UNITED STATES PATENT AND TRADEMARK OFFICE

APPLICATION NO.	FILING DATE	FIRST NAMED INVENTOR	ATTORNEY DOCKET NO.	CONFIRMATION NO.
10/023,907	12/21/2001	Tatsuto Yamazaki	43888-123	5239

Office Action Summary

DETAILED ACTION

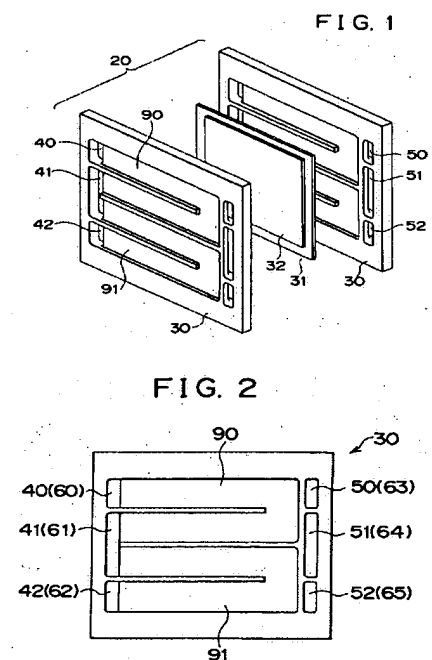
Mizuno et al disclose a polymer electrolyte fuel cell having a stack structure formed by stacking a plurality of unit cells. Figures 1 and 2 below show the unit components and the separators (SECTION 0042). The unit cell 20 has an electrolyte membrane 31, an anode 32, a cathode and a separator 30 (SECTIONS 0043/0048).

FIG. 16

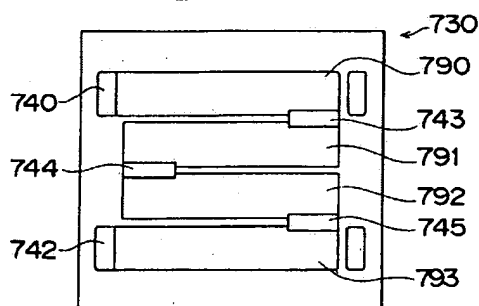
Figures 16-17 below show separators having the gas transit manifold construction is provided only for the oxidative gas. It is evident from Figures 16-17 that the separator comprises oxidant gas inlet/outlet manifolds comprising holes on the side and gas flow channels.

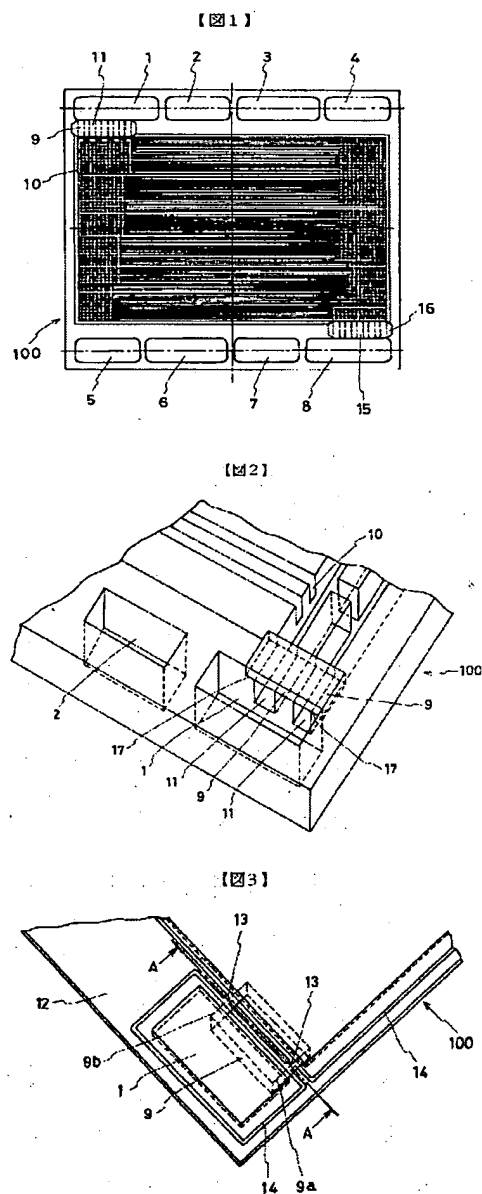
discharge port are formed into a tunnel structure in the fuel cell separator 100. **Figures 1-3** below illustrate the separator comprising the grooves and the tunnel structure.
